Sail Auxiliary - All Group No. 17 Tappet Clearance	April 30, 1980	Bulletin No. 17001 (1001)

Subject: Tappet Clearance for Intake and Exhaust

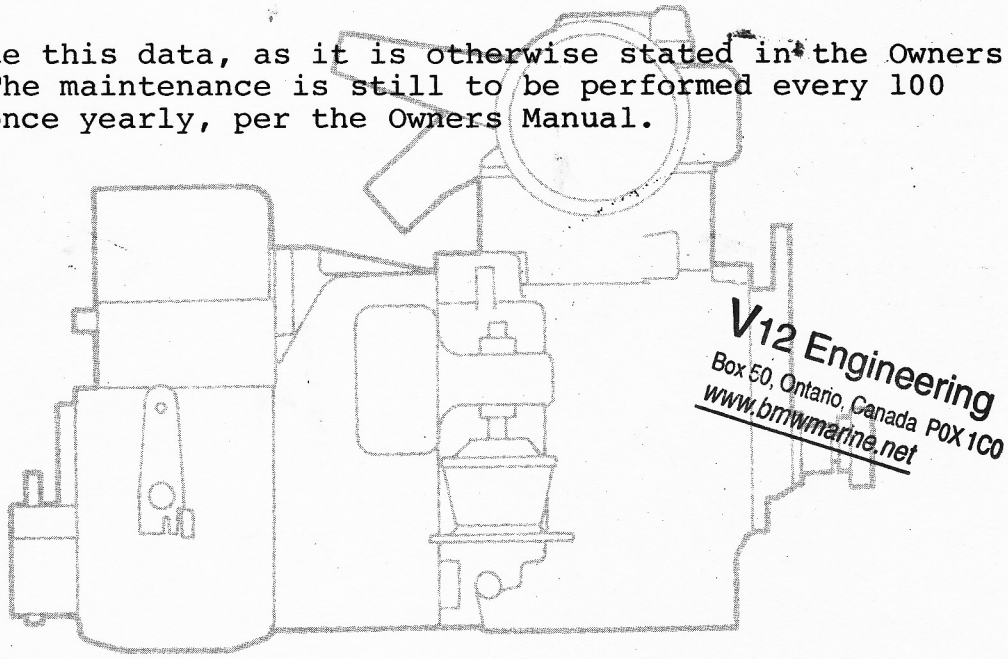
Please note this data, as it is otherwise stated in the Owners Manual. The maintenance is still to be performed every 100 hours or once yearly, per the Owners Manual.

Engine	Clearance for Intake and Exhaust	
D-7	0.15mm	(0.006")
D-12	0.35mm	(0.014")
D-35	0.40mm	(0.016")
D-50	0.40mm	(0.016")
